FERGUSON TOWNSHIP PLANNING COMMISSION Regular Meeting Agenda Monday, April 11, 2022, 6:00 PM

SUBJECT: Tussey Tracks - Centre Animal Veterinary Hospital Preliminary Land Development Plan

SUBJECT: Center Animal Hospital Preliminary Land Development Plan 3rd Review

SUBJECT: Centre Animal Hospital Preliminary Land Development Plan and Stormwater

SITE LAYOUT PLAN

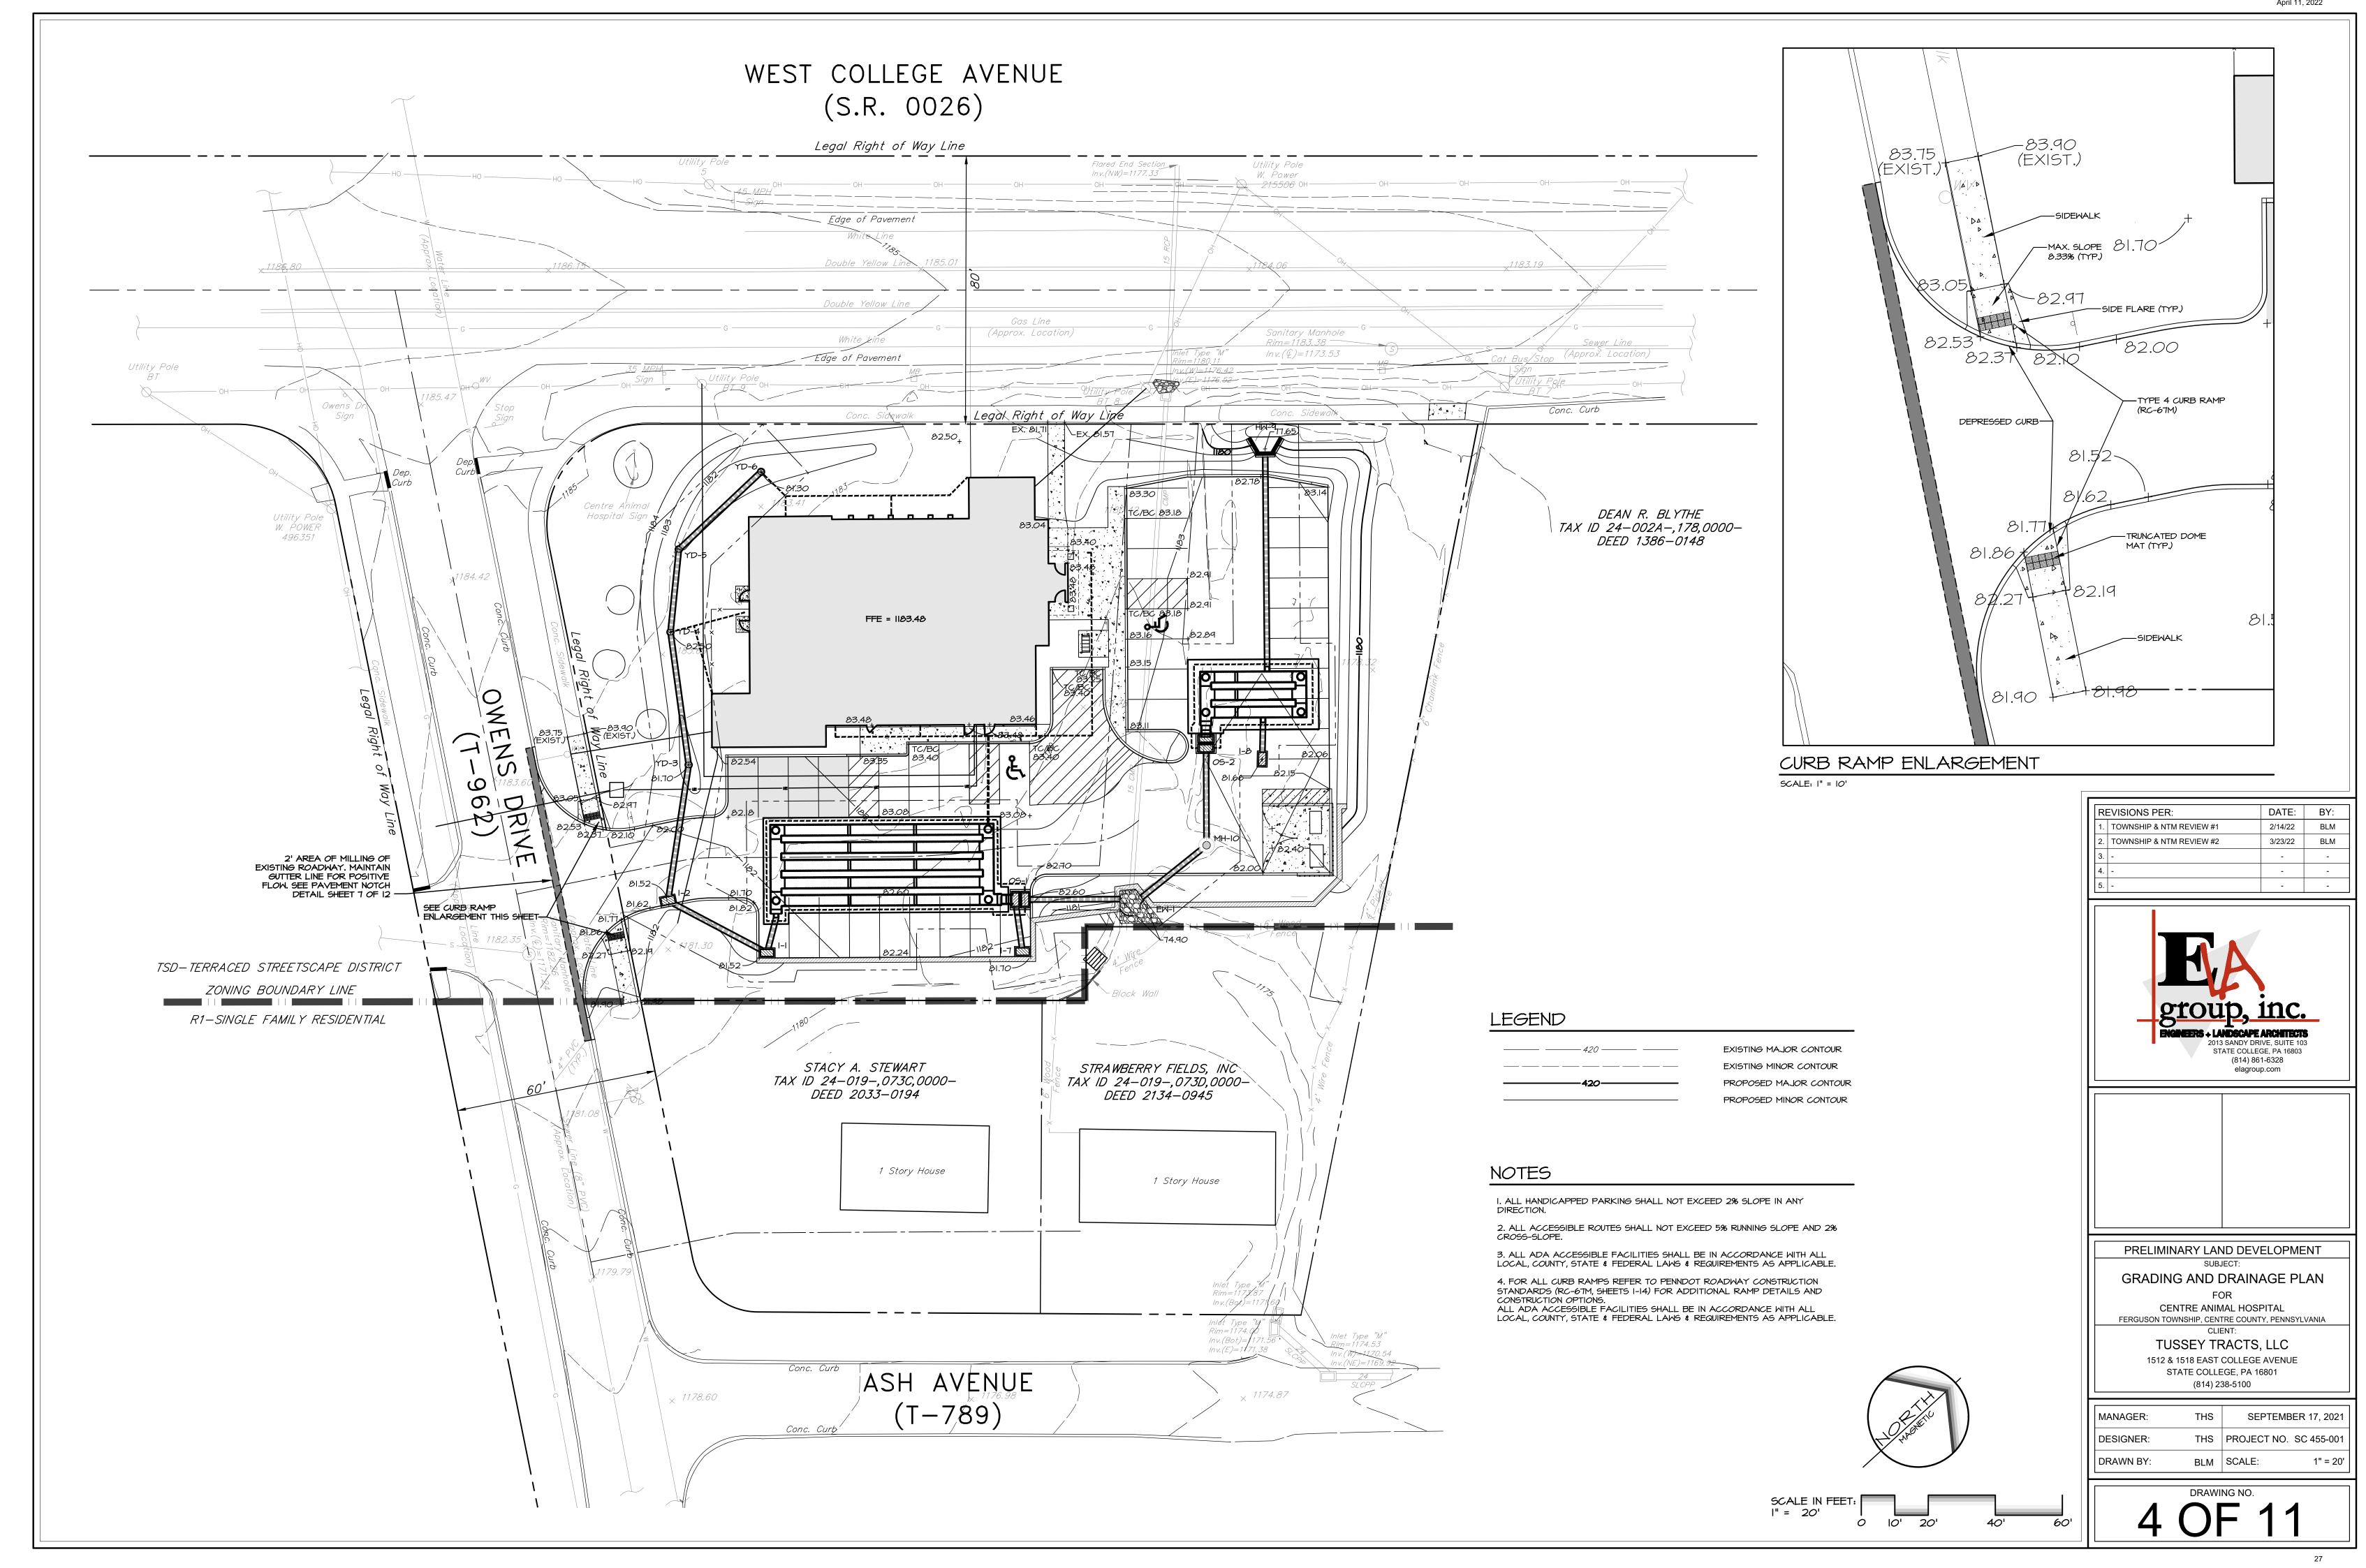
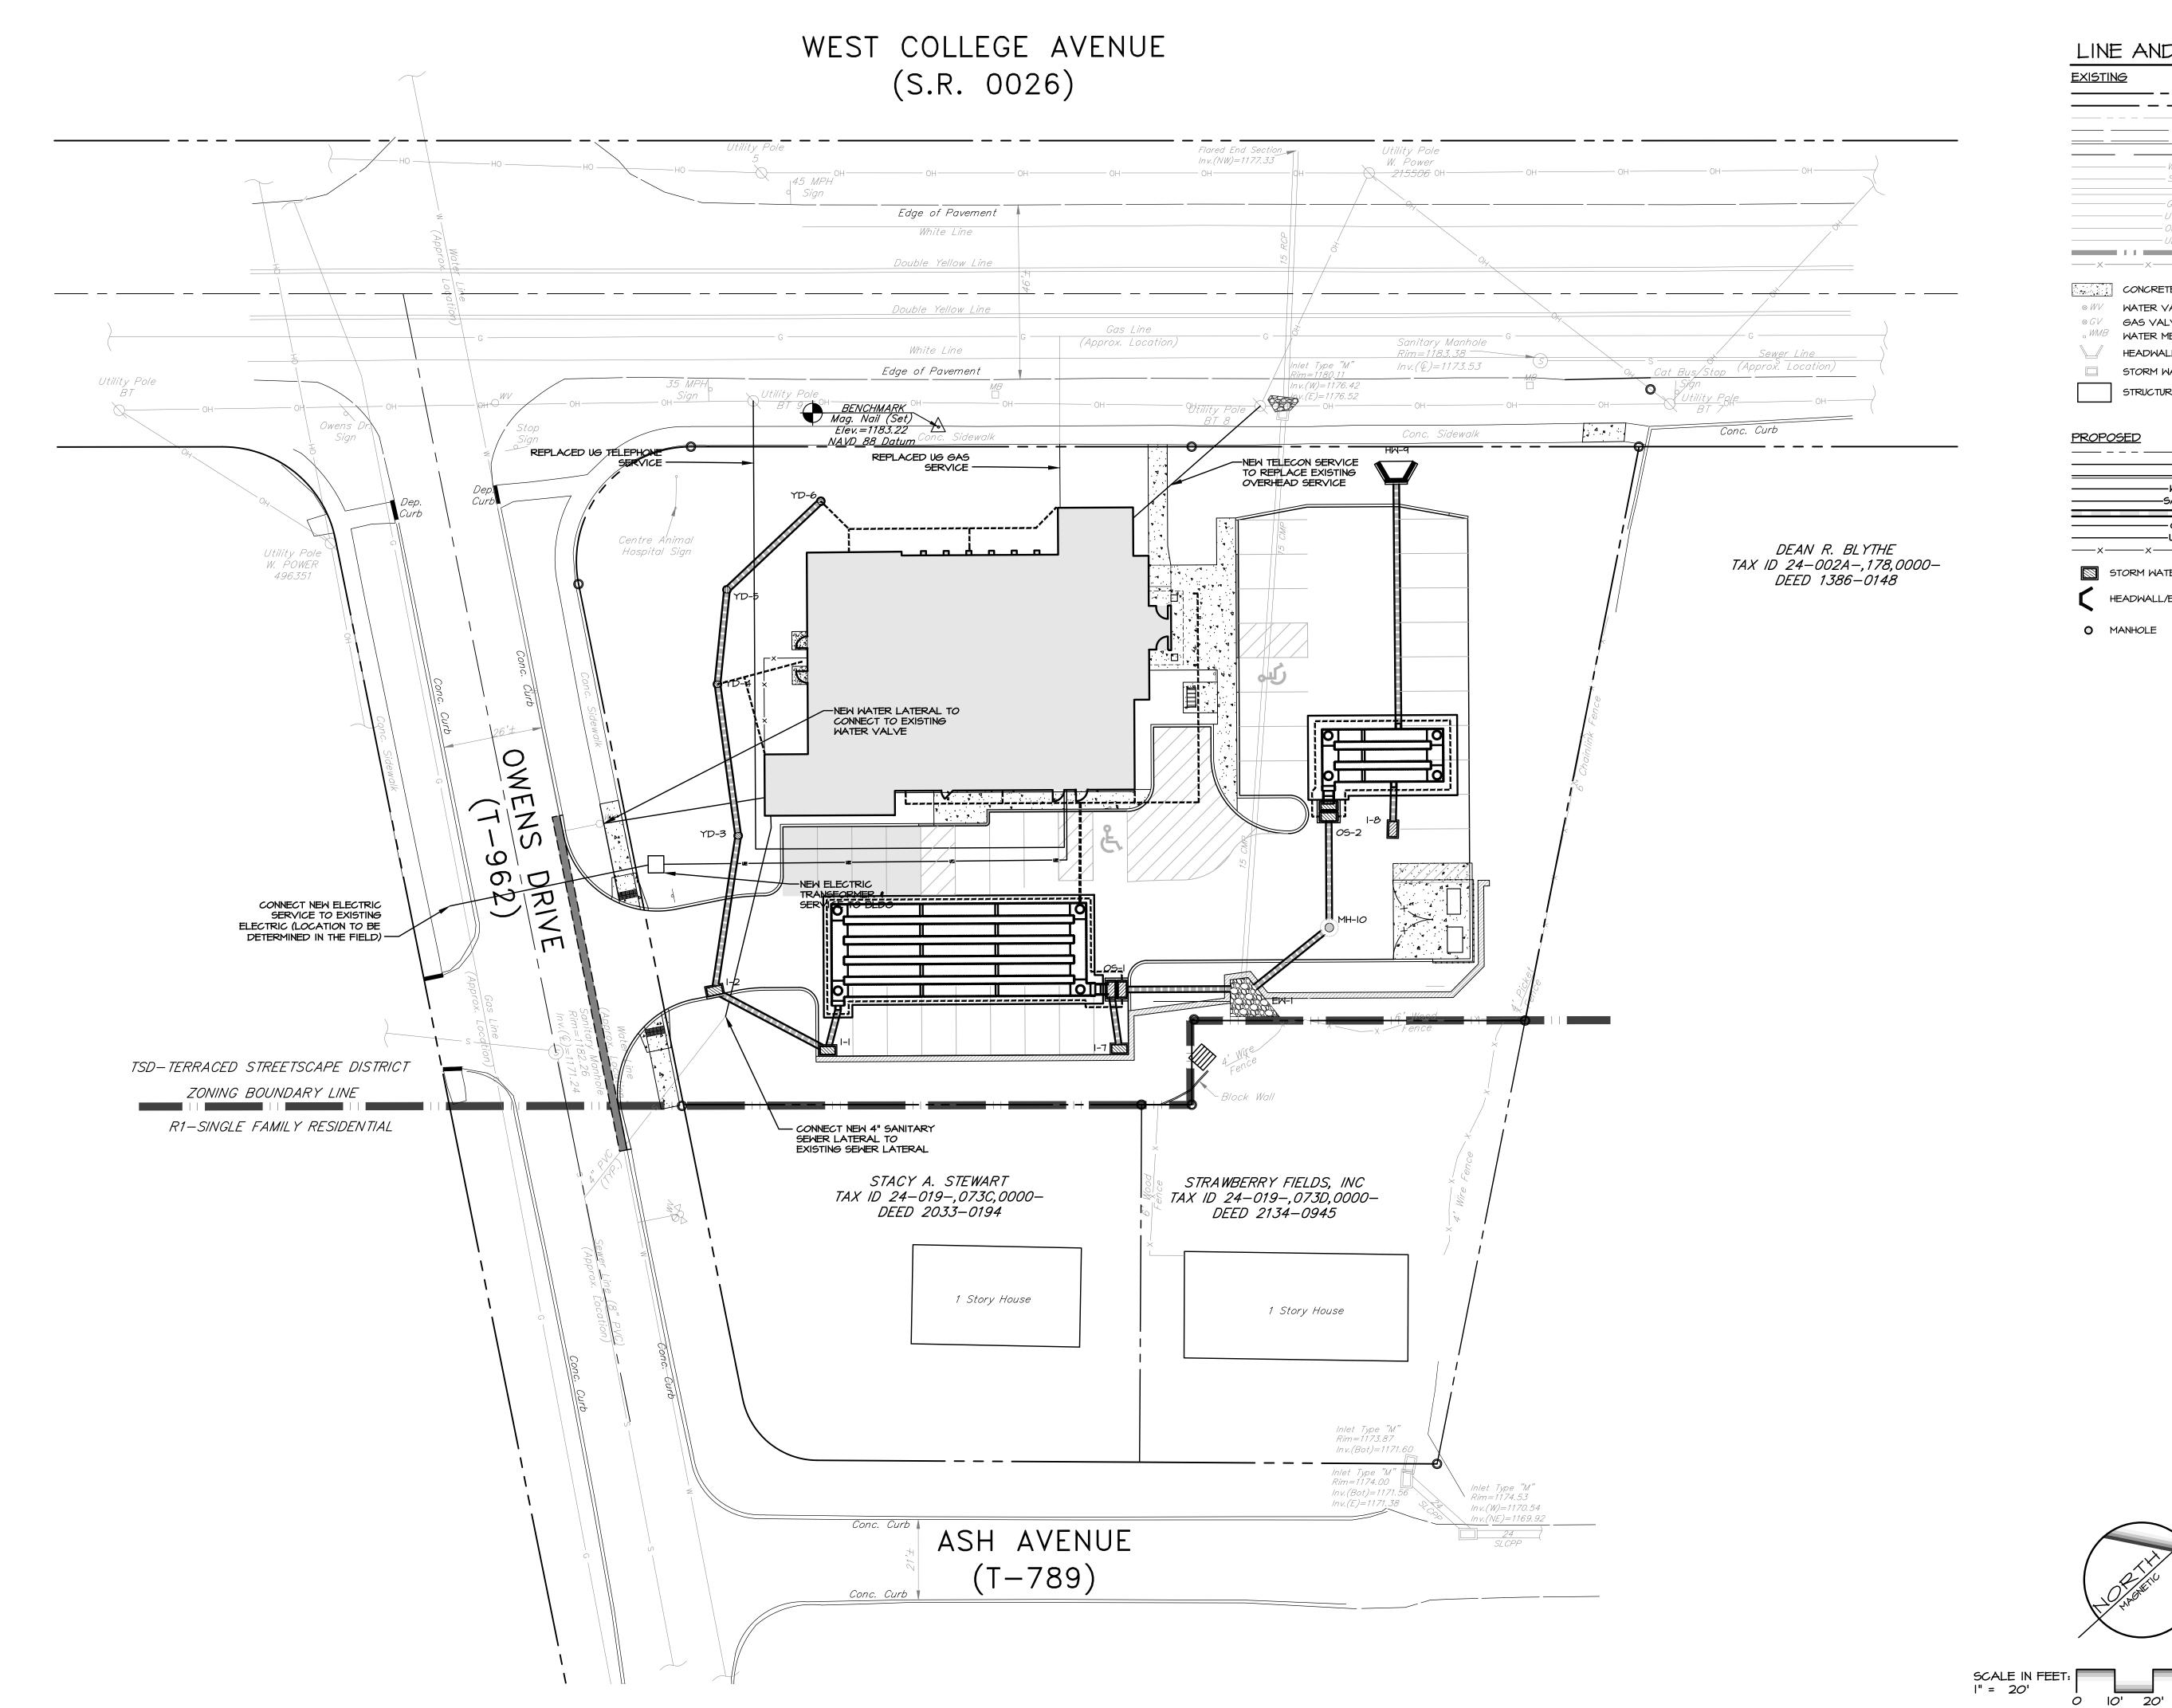
2. On Sheet 3:

a. The plan depicts four pervious parking spaces, perhaps to meet maximum impervious coverage. The detail on Sheet 7 for Concrete Unit Paver does not provide a pervious design and is therefore not considered pervious. To get credit for being pervious, the underlying area needs to be designed as pervious to allow for infiltration and should be documented in the stormwater management site plan and report. Pending review of SWMSP.

SUBJECT: LIGHTING PLAN

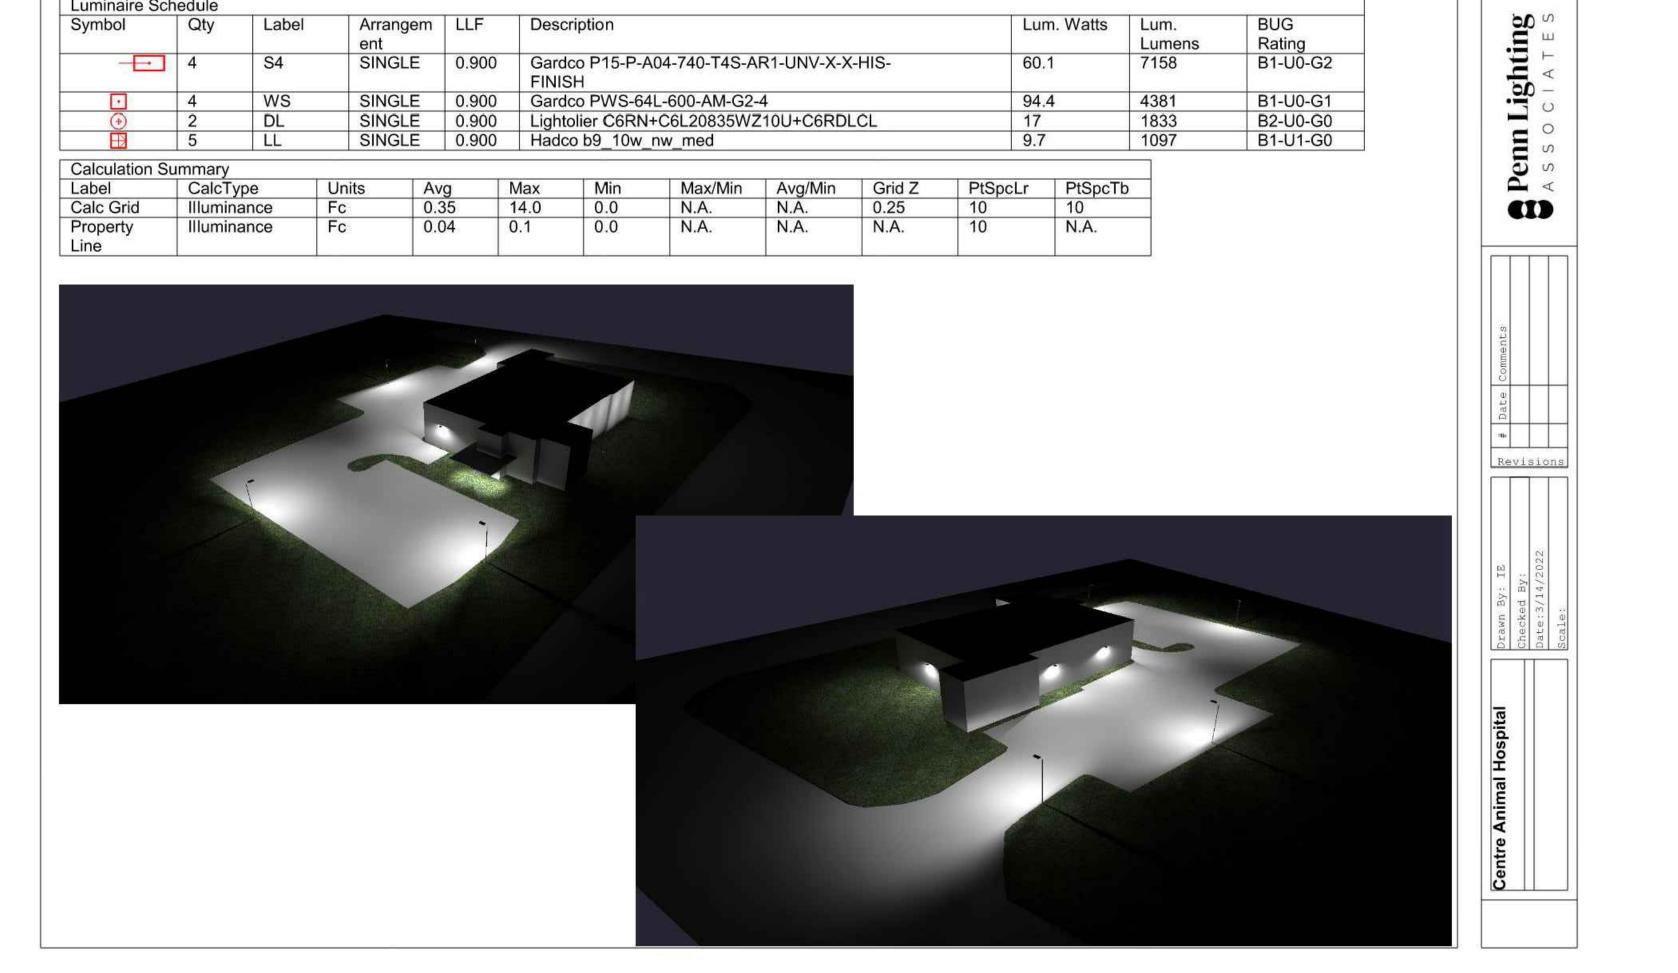
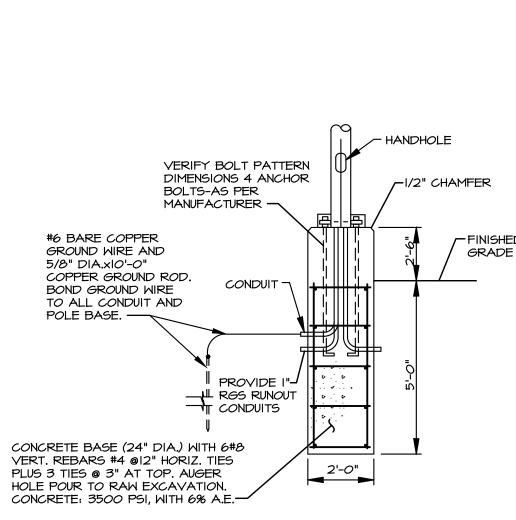
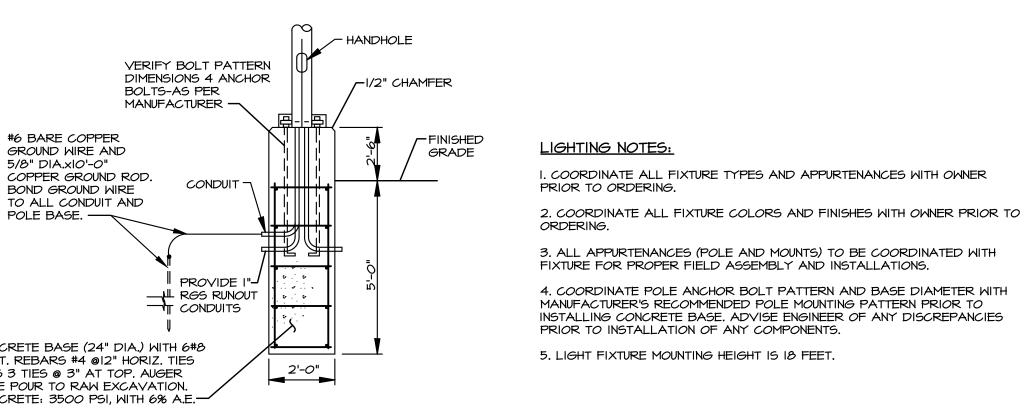
2. The lighting exceeds the allowable maximum maintained luminance levels along the rear property line as outlined in §4-127.C. of the Township ordinance requirements. Update the plans and resubmit.

April 5, 2022 Response: The pole mounted lighting fixtures have been revised to include glare shields. These fixtures meet the requirements outlined in §4-126 of the Township Code relative to the use of cutoff luminaires.

April 5, 2022 Response: Comment addressed.
